UNITED STATES PATENT AND TRADEMARK OFFICE

APPLICATION NO.	FILING DATE	FIRST NAMED INVENTOR	ATTORNEY DOCKET NO.	CONFIRMATION NO.
09/868,938	07/18/2001	Kiyoshi Nishio		4331

Office Action Summary

FINAL ACTION

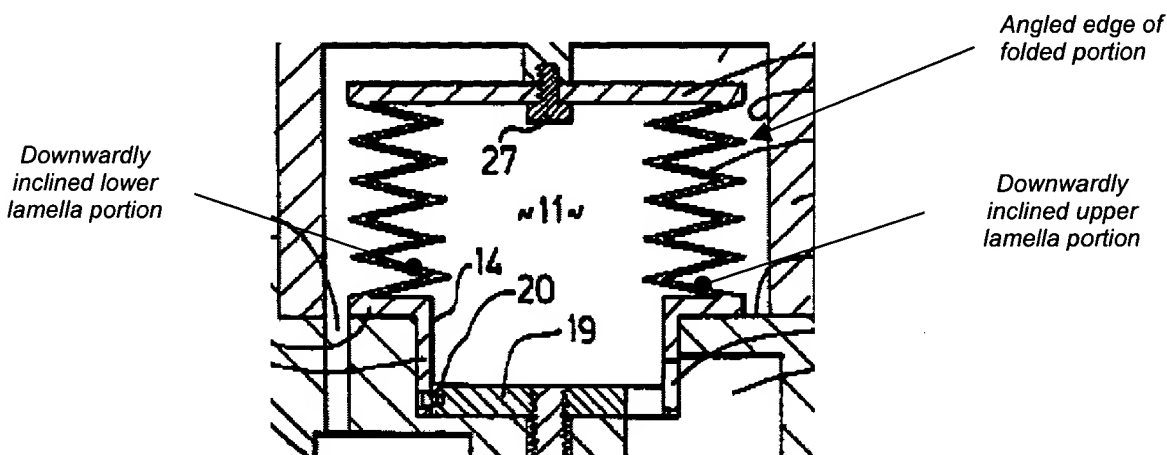
2. Claims 7 and 10 are rejected under 35 U.S.C. 103(a) as being unpatentable over Thomin et al. (WO 99/31388) in view of Boedecker et al. (4,655,690) and Thompson (3,394,631). Thomin et al. teach a fluid apparatus having a bellows 12 with extending and contracting portions configured by forming ridge-like folds and valley-like folds 18 in a vertically alternate and continuous manner, that are extendingly and contractingly deformable in an axial direction. The bellows are placed in a pump body 1 such that the axial direction defines a vertical axis. Figure 2 illustrates an inner pumping chamber 11 (corresponding to the claimed liquid chamber) formed inside of bellows 12; an outer pumping chamber 10 (corresponding to the claimed air chamber) formed outside of the bellows 12; and a suction (or inflow, as in claim 4) port 43 and a discharge (or outflow, as in claim 4) port 45 formed in an inner bottom face of the pump body facing the inner pumping chamber. Figure 2 further illustrates that the bellows are formed into a shape

in which a lower one of upper and lower lamella portions of each of the ridge-like folds is downwardly inclined toward the vertical axis, in both the extending and contracting state (see the accompanying figure), and in the contracting state, the upper and lower lamella portion of each ridge-like fold is formed to be downwardly inclined.

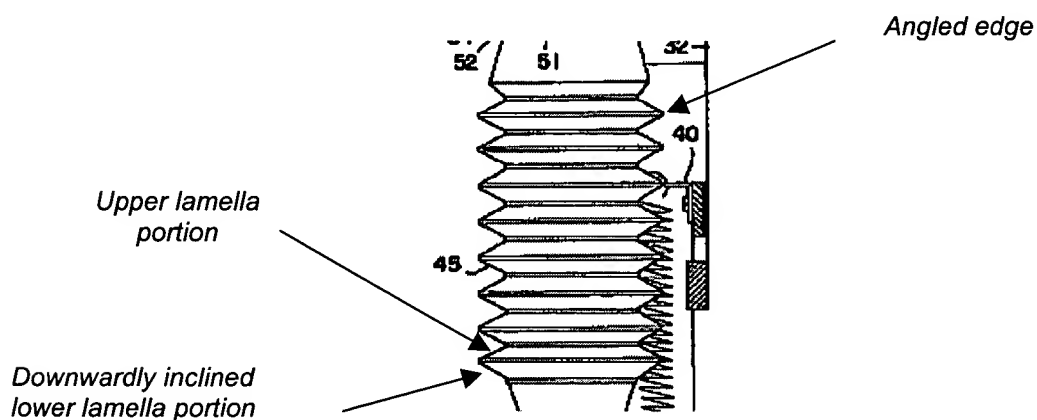
While Thomin et al. teach most of the limitations of the claims, they do not explicitly teach that the bellows have vertically extending portions connecting their respective extending and contracting portions. Thompson teaches such a coating 26 (corresponding to the claimed vertically extending portion) that "serves to form a flexible seal between each of the adjacent washer surfaces thereby avoiding the necessity for special treatment of the mating surfaces" (column 4, lines 69-72). Therefore, it would

have been obvious to one of ordinary skill in the art to include a vertically extending portion, as taught by Thompson, in the Thomin et al. invention in order to advantageously seal the surfaces, and enable the bellows to be assembled as a singly contained unit that is easily assembled into the pump.
